**DUCATI NORTH AMERICA Inc.** 237 West Parkway  
Pompton Plains, NJ 07444-1028  
Tel. 973-839-2600  
Fax 973-839-2331

**99V-360 (01)**

**Ducati Motor Spa. Has determined that a safety recall campaign should be conducted on certain Ducati motorcycles 916 MY 1994 through MY 1998 and certain 748 MY 1997 through MY 1999.**

Ultrasonic testing Recall Campaign. Service and repair instructionsDucati affected models:

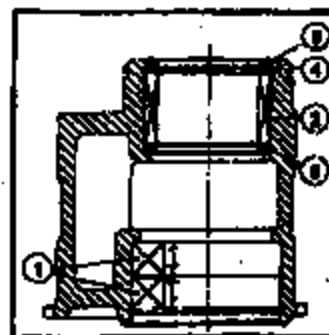
4. The roller bearing (2) needs to be taken apart before it can be removed. Use a screwdriver to remove the cage (A) and the roller (B) placed inside the casing.

5. Heat up the hub area where the casing is located by blowing it with hot air.

6. Drive out inner seal (6) and casing (C) with a suitable drift pressing from the chain end.

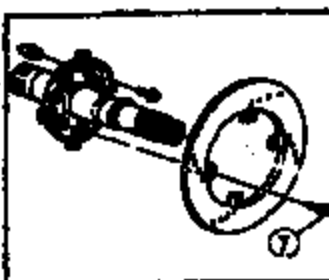
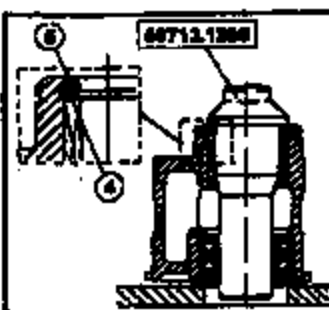
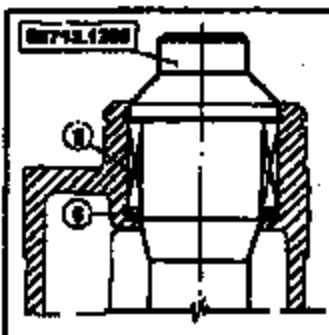
8. Heat up the roller casing seat (2) in the hub area where the casing is located by blowing it with hot air.
9. To fit the new seals, you will need drift part # 887131285. Place the hub that goes on the chain end on a flat-faced stand with a hole for drift end to come out. Place the roller bearing (2) and inner seal (6) on the drift. The flat face of the seal should be facing the hub. Use the drift to push seal and roller bearing all the way in until they locate against the hub.

10. Install the circlip (4) with the sharp edge face towards the roller bearing.
11. Fit the upper seal (5) onto the drift with the flat face pointing outward. Push it until it touches the circlip.

12. Smear bearing (2) and seal (5) and (6) with moly-grease.
13. Fit the original pins (7) onto the outer end of the wheel spindle. Apply some Loctite 242 on the threads and torque the four screws (8) to 11 Nm (7.95 Ft/lb).

***See exploded view of the components of the rear eccentric hub to aid understanding and avoid any mistakes.***

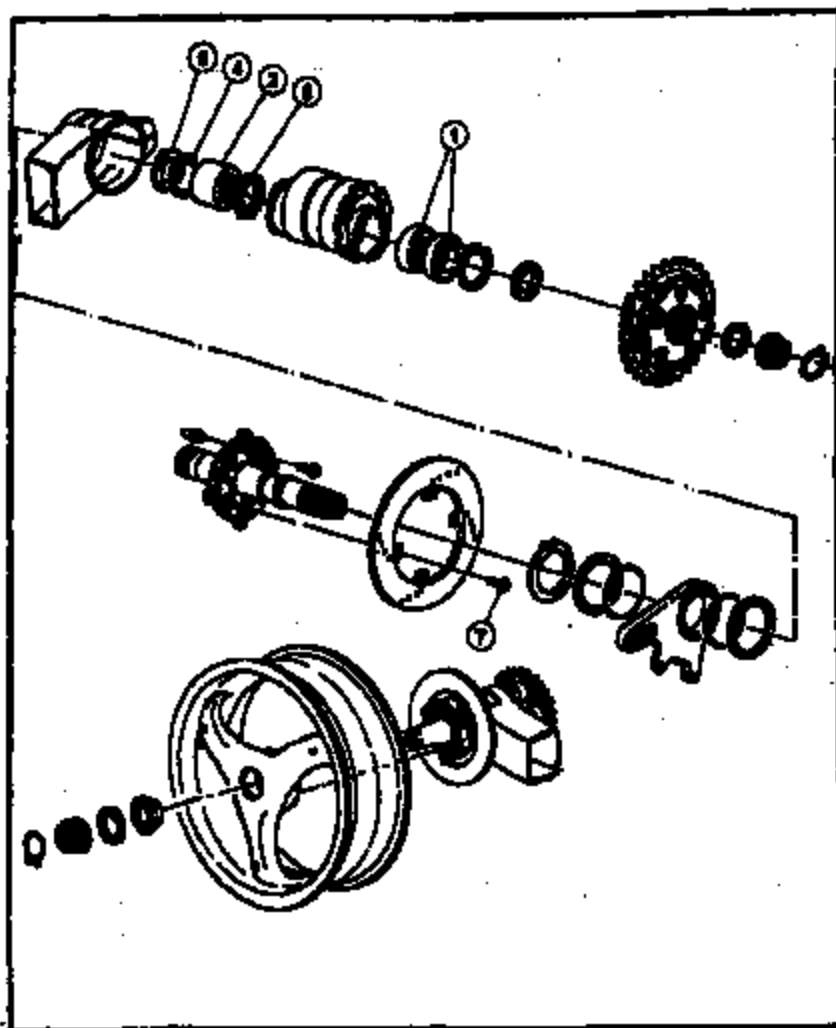
WHEEL SHAFT	81810153C	1
BRAKE DISC BOLTS	00008272	4
ROLLER BEARING	70240081B	1
SEAL	83040131A	2
WHEEL SHAFT	81810381A	1
BRAKE DISC BOLTS	77182882B	4
ROLLER BEARING	70240081B	1
SEAL	83040131A	2

- 14. Fit the original brake disc on the spindle. Secure it with 4 new screws (9). Apply Loctite 271 on the threads and torque them to 10 Nm. (7.23 Ft/lb).*
- 15. Refit the caliper holder plate, and the wheel spindle assembled with the disc. For reassemble instructions of the parts you have removed reverse the procedure on step 1. Apply grease to threads and head underside of the fastening screws for the brake caliper and torque to 25 Nm, (18 Ft/lb).*
- 16. Refit the sprocket holder plate and sprocket assembly. Apply some grease on the threads and head underside of retaining nut And torque to 137 Nm. (99.5 Ft/lb). Reinstall circlip.*
